DEVELOPMENT REVIEW BOARD
SUPPLEMENTAL SUBMITTAL

PROJECT NO. PR-2021-005459
Application No. SD-2021-00163 SI-2021-01248

**RE: PR-2021-005459 RESPONSE TO DRB COMMENTS
LOT 1A BLOCK 2 & LOT 2-A-1 BLOCK 2 SUNPORT PARK
2900 TRANSPORT ST NE**

DRAWING TITLE
BUILDING 100 COLOR ELEVATIONS

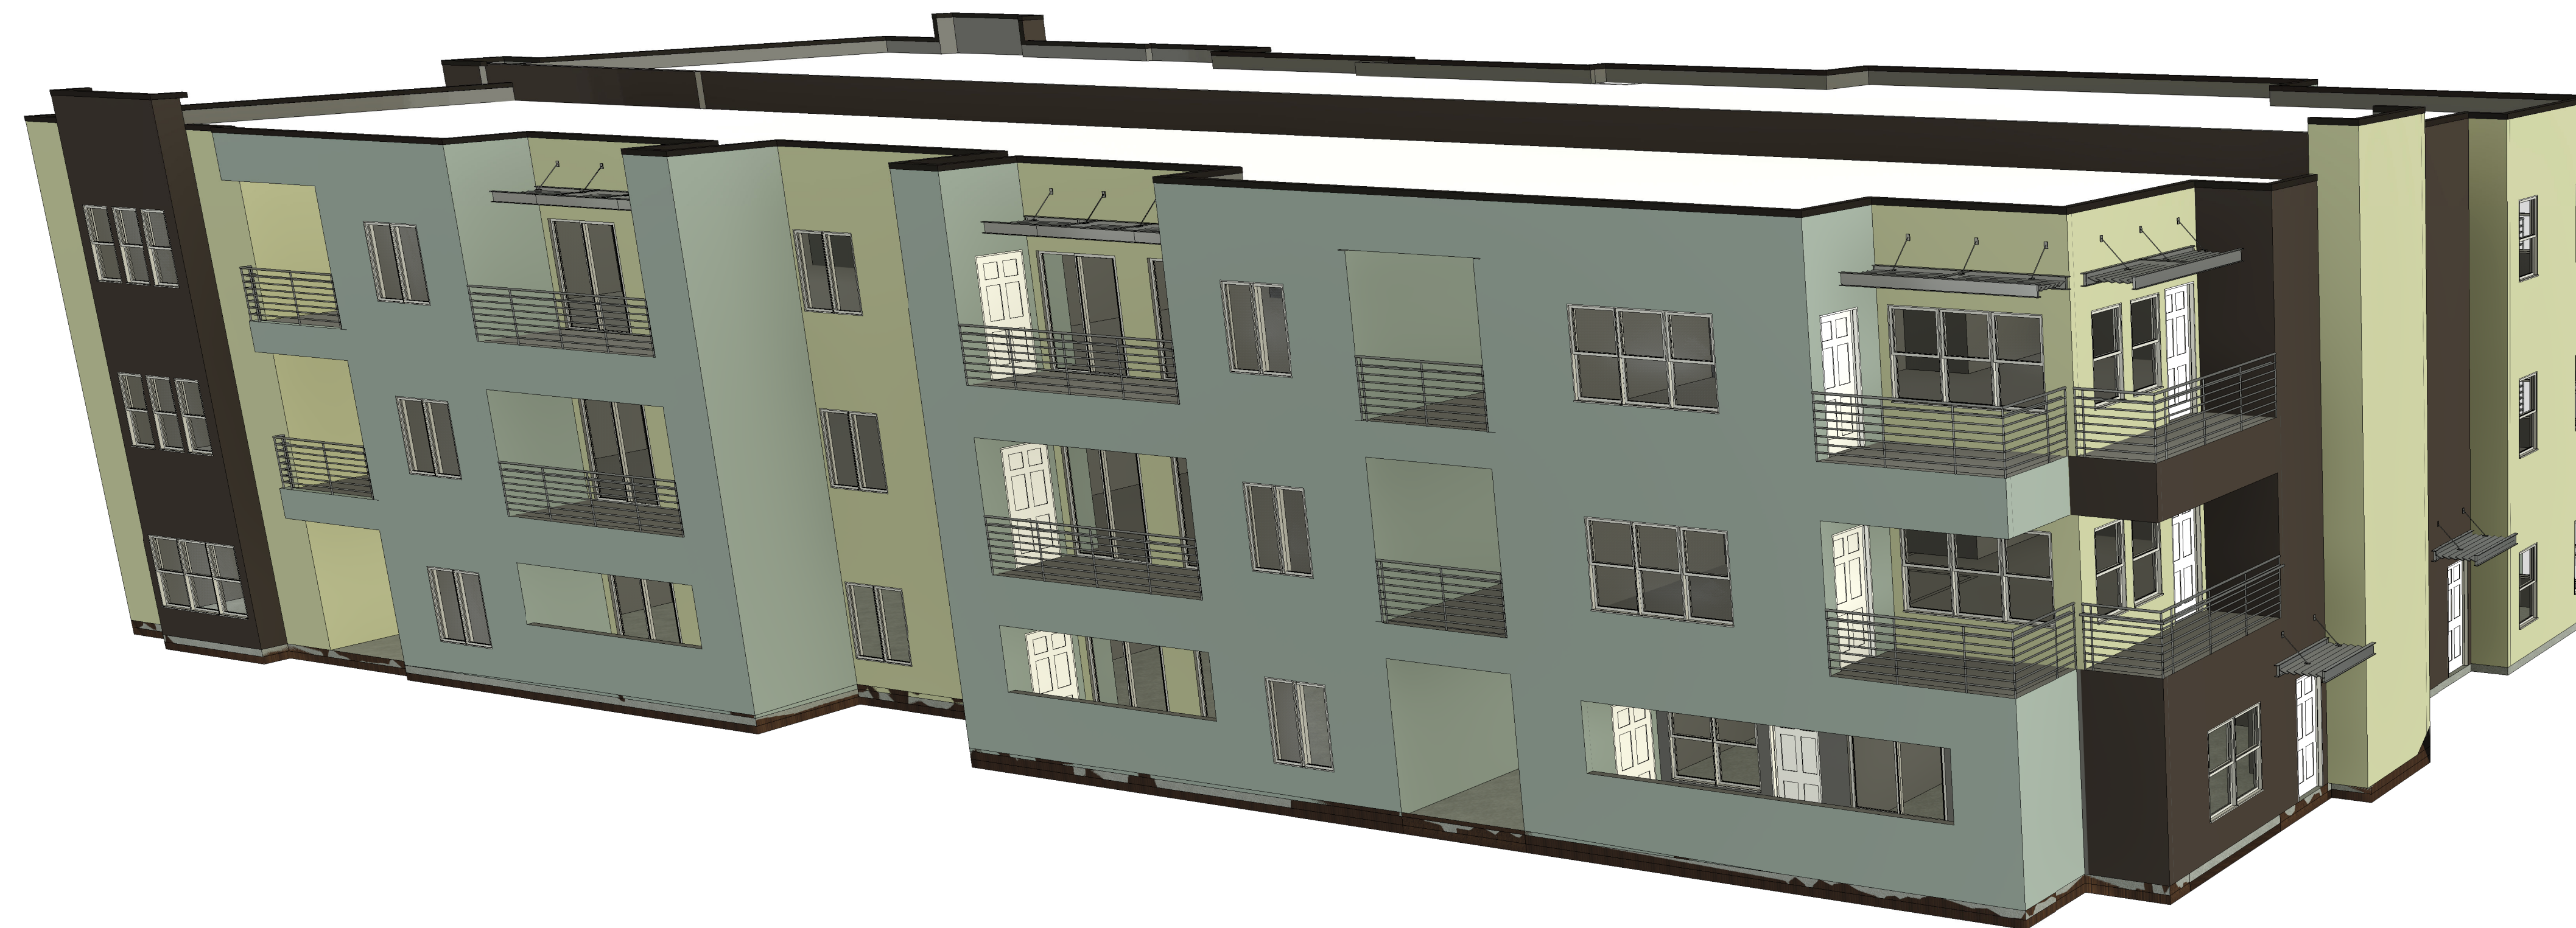
11. The applicant must confirm that the Façade Design requirements of 5-11(D) of the 2020 IDO are being met in a comment response letter and how they are being met. Please note requirement 5-11(D)(1) requiring that entrances be emphasized and provide weather protection. Also, note 5-11(D)(2)(a) Windows requiring heat mitigation features for western windows and recessed or framed windows. Please also note: 5-11(D)(2)(b)(4) Articulation requiring that balcony massing, material, or color shall vary to create visual interest.

RESPONSE: Shade awning callouts added to building elevations, most entrances to the units are off of breezeways. Note added to building elevations to recess windows 2", shade awnings provided at windows on upper floors. Balconies provide shade to glazing below them. Balconies vary in massing and material, reference building elevations included in this resubmittal.
